**AGENDA FOR BOARD OF TRUSTEES REGULAR MEETING
VILLAGE OF IRVINGTON, NY
MONDAY, OCTOBER 19, 2020 AT 7PM
** MEETING WILL BE HELD BY VIDEO CONFERENCE**

Following the conclusion of the Regular Meeting, the Board of Trustees will hold a Public Hearing on the Findings of Fact for 2 Hancock Place - Takashi and Akiko Okumura appeal of Architectural Review Board decision

EXTENSION AND RENOVATIONS TO THE
OKUMURA RESIDENCE
 2 HANCOCK PLACE, IRVINGTON, NEW YORK
 CHRISTINA GRIFFIN ARCHITECT PC
 10 Spring Street, Hastings-on-Hudson, NY 10706

ARB SUBMISSION 7-6-20

S-1

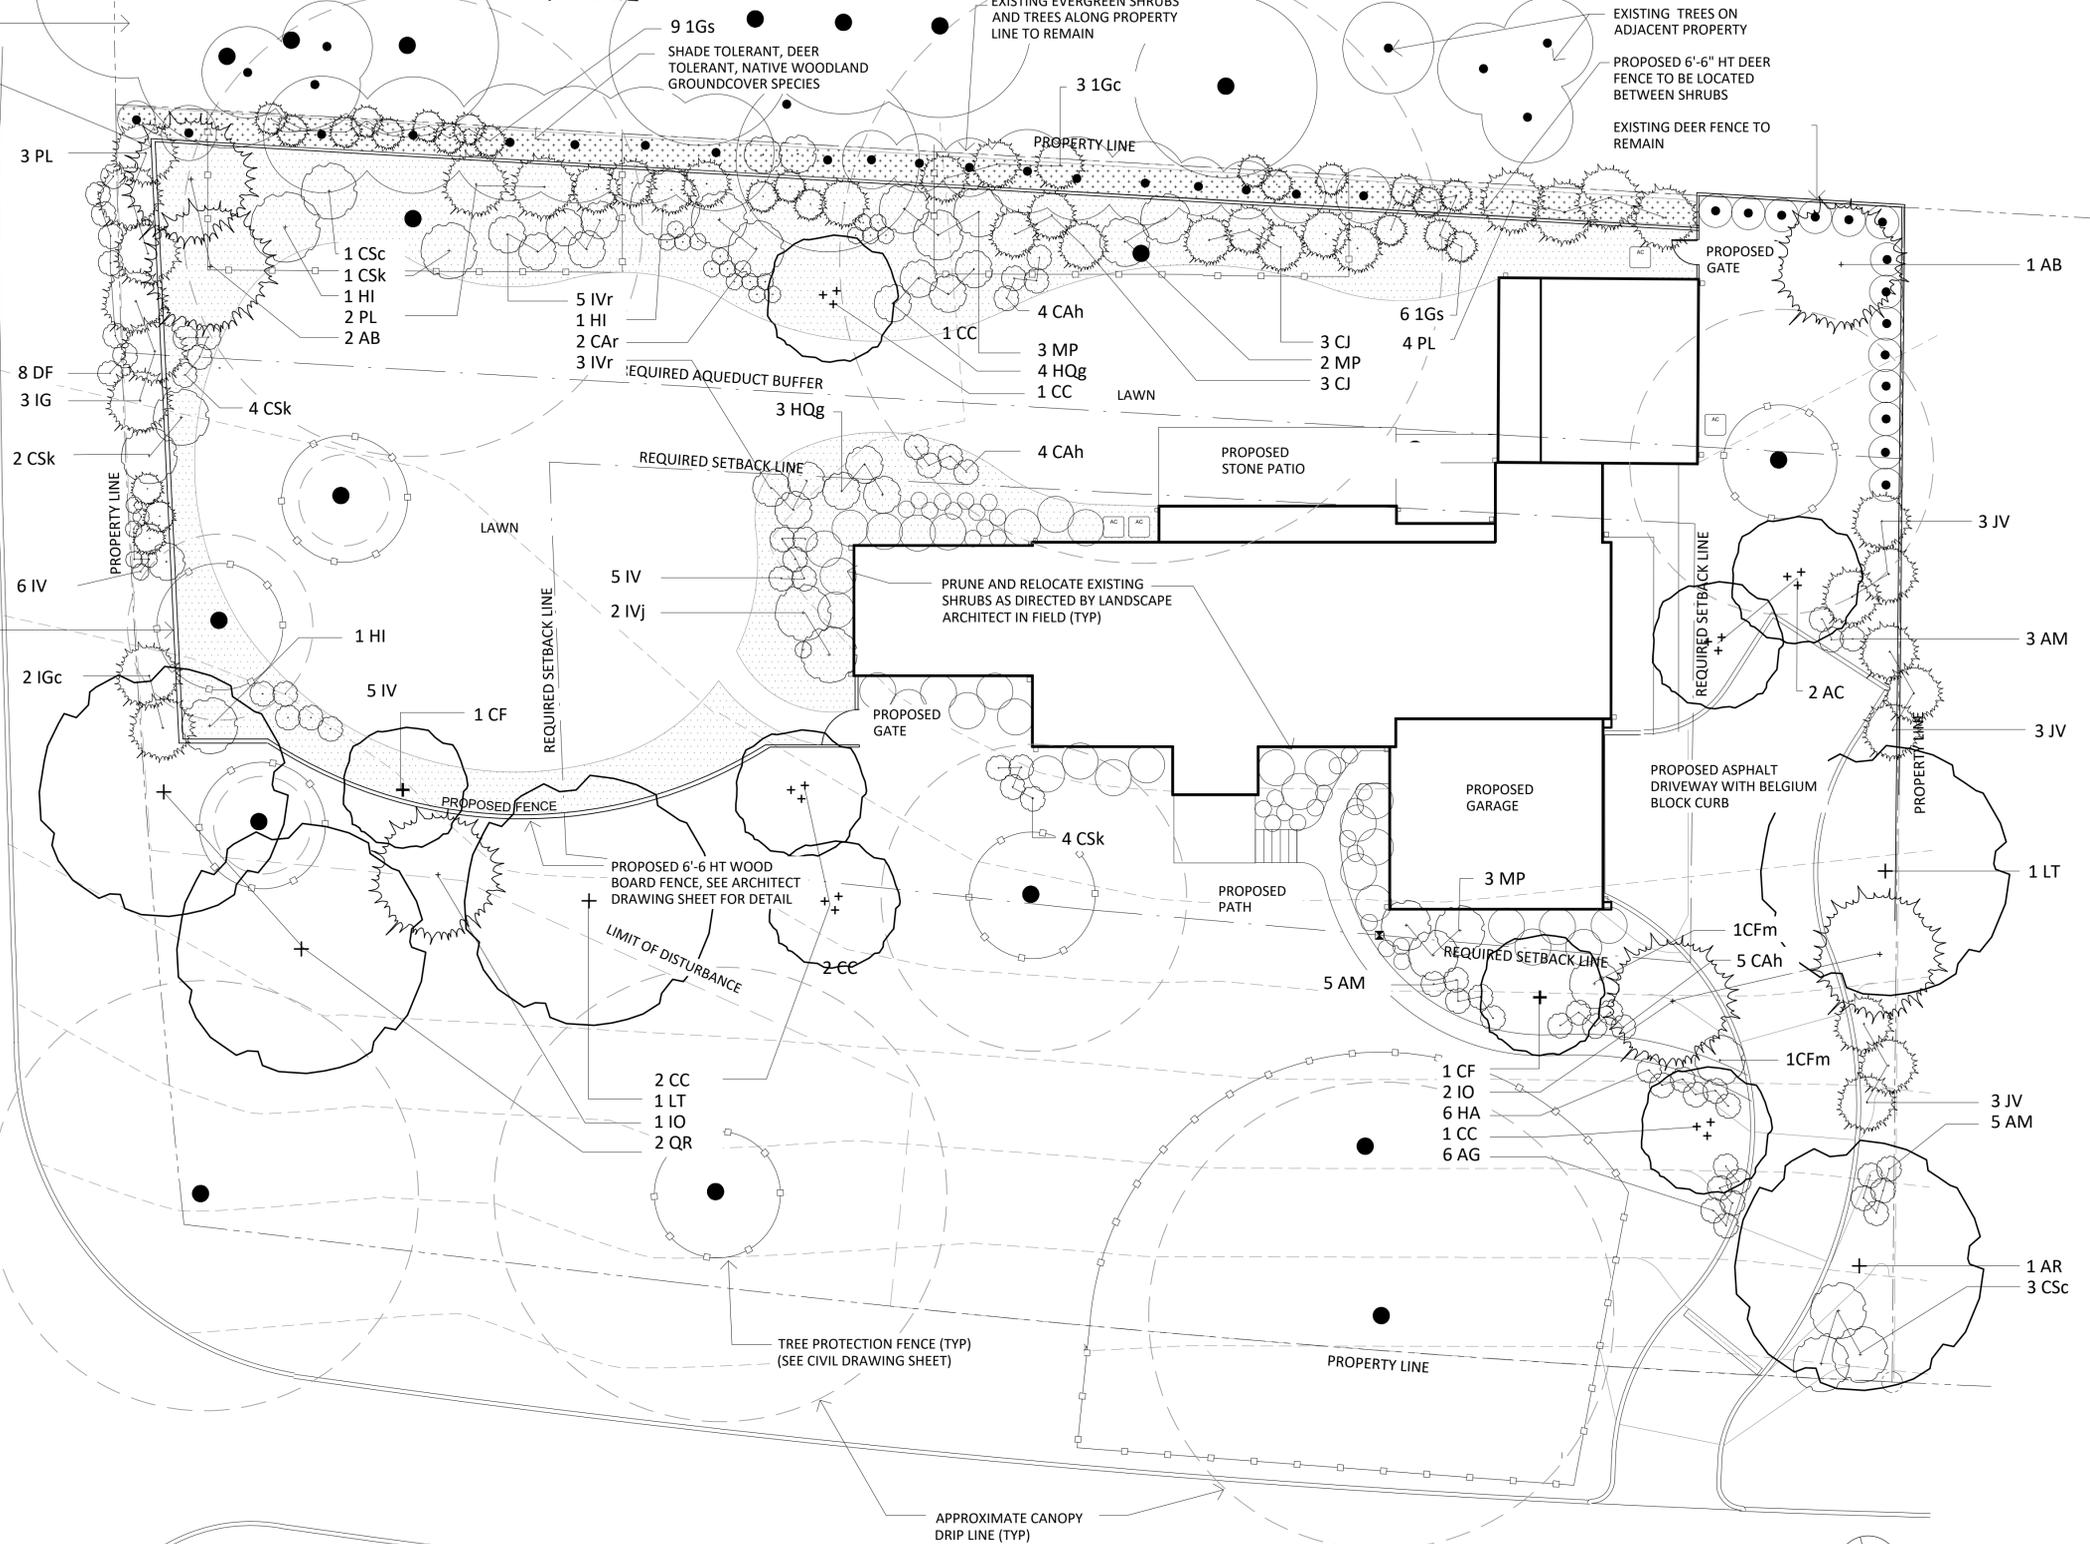
After obtaining final site development plan approval and the variances, Okumura applied to the ARB for what was supposed to be a review of the exterior features of its renovation and addition. To that end, Okumura appeared before the ARB on April 27, 2020; June 22, 2020; and July 27, 2020. At those meetings, it became clear that the ARB had issues with the size of the addition and the proposed fence, the location of both were approved by the Planning Board as noted on the approved site plan (See Sheet S-1).

Here, the location of the fence as shown on the Okumura site plan has been approved by the Planning Board and it is not within this Board's purview to modify it. However, the fence's exterior appearance, *i.e.*, its design and materials, is clearly within the ARB's purview.⁶
